**DECISION NOTICE UNDER S 335 SUSTAINABLE PLANNING ACT 2009:  
DEVELOPMENT APPLICATION FOR ANDREASSEN ROAD, CRAIGLIE**

House building envelope

Drawing or Document	Reference	Date
Proposed Building Pads Plan	RECS 42-2013 C01 Issue B	11 September 2013
Sections	RECS 42-2013 C02-2 Issue A	11 September 2013

PROPOSED BUILDING PADS PLAN

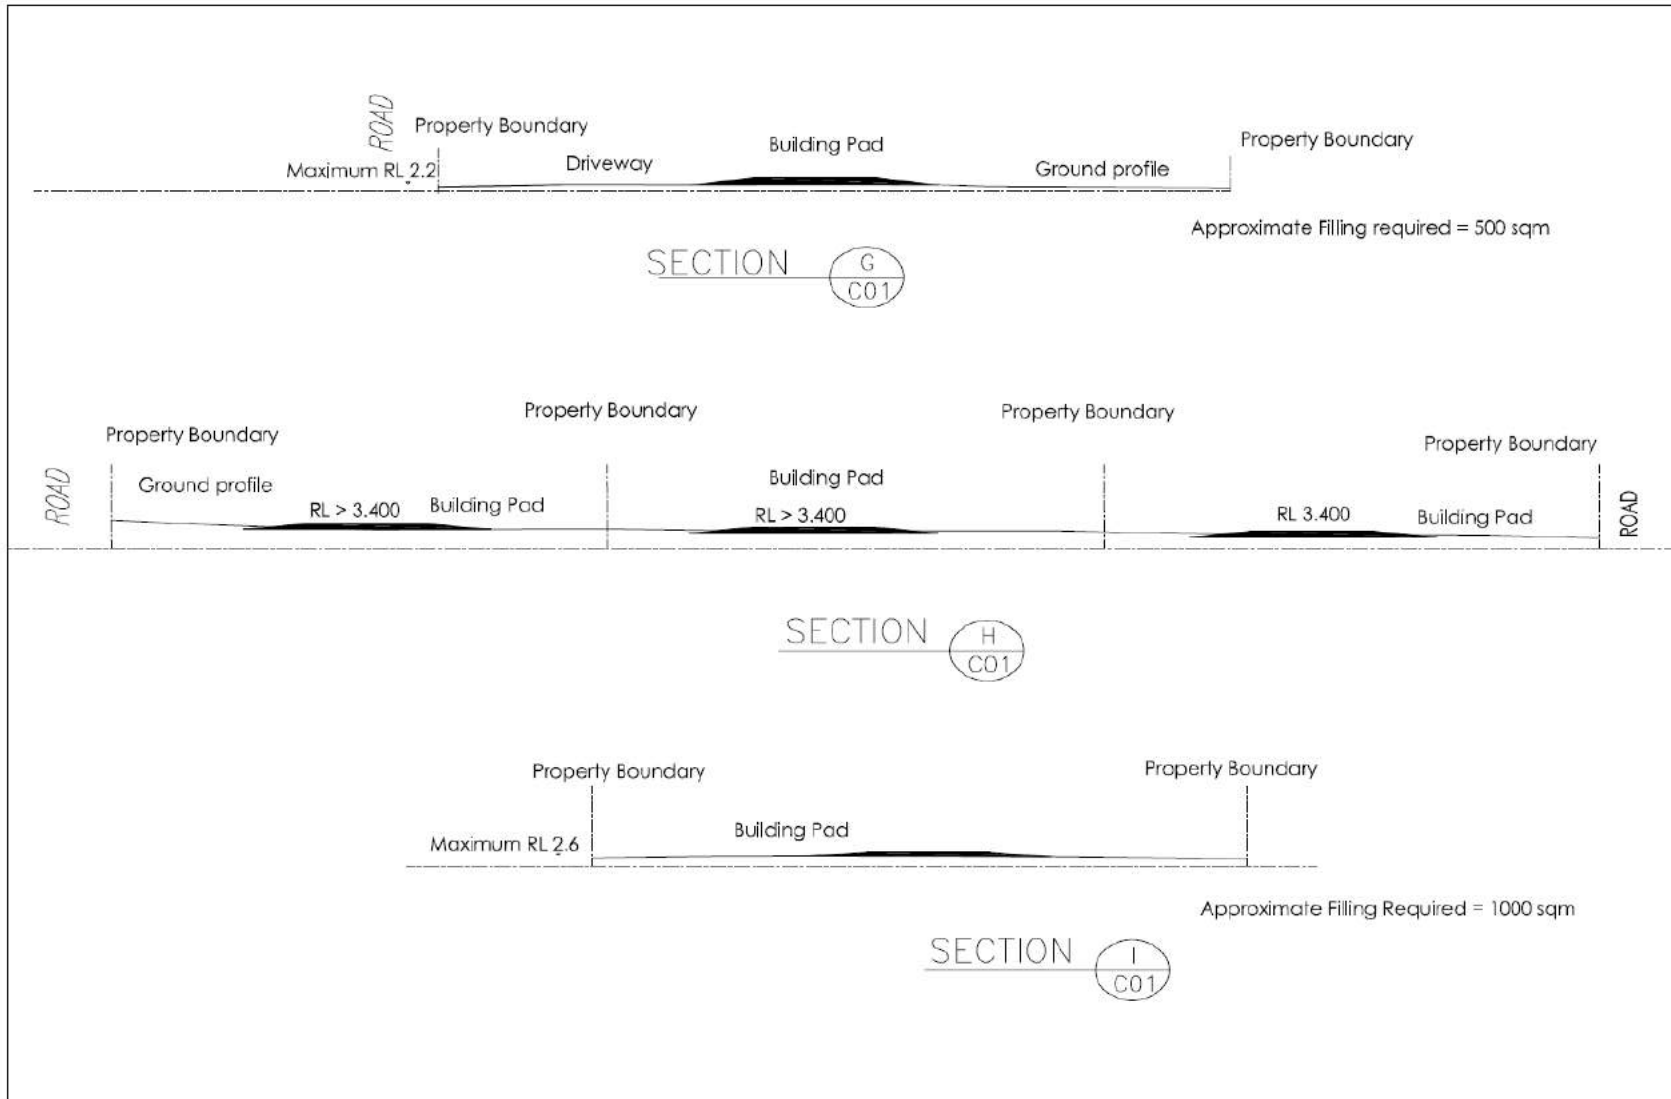
5. The proposed driveway to the building pad from the unnamed internal access road, as shown on the Building Pad Plan 42-2013 C01 Issue B prepared by RECS Pty Ltd and dated 11 September 2013, must be constructed at a level that provides immunity from a Q10 ARI flood event. The construction of the driveway must not impede overland flows in a manner that creates a direct or cumulative impact on neighbouring or downstream properties. In this context, the Registered Professional Engineer of Queensland is required to provide a plan of any proposed culvert works associated with the driveway that demonstrate the free movement of stormwater across the site.

6. The proposed earthworks on the site require an application for Operational Works. The concept for filling as detailed on Proposed Building Pad Plan 42-2013 C01 Issue B prepared by RECS Pty Ltd and dated 11 September 2013, will be required to be submitted in addition to the following:
  - a. Details identifying the specific movement of fill material around the site. This is also to include detail on the total volume of material proposed to be brought onto the site and management of this;
  - b. Details on the stockpiling and transportation of fill material; and
  - c. Details identifying that all earthworks will be compliant with the requirements of relevant drainage conditions contained in Conditions 4 and 5 above.

## APPENDIX 2: STANDARD DRAWING RURAL ALLOTMENT ACCESS

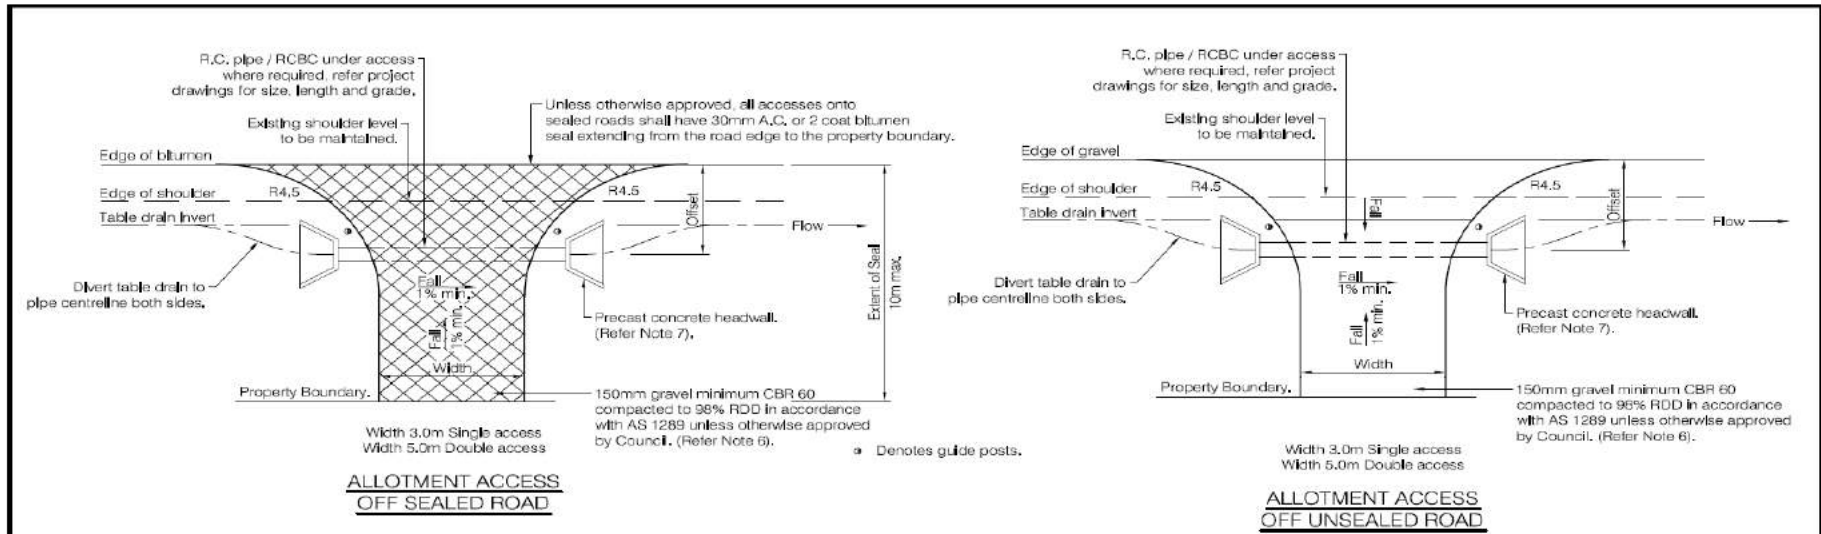
Access into the driveway must be in accordance the *FNQROC Drawing S1105*, attached as Appendix 2.
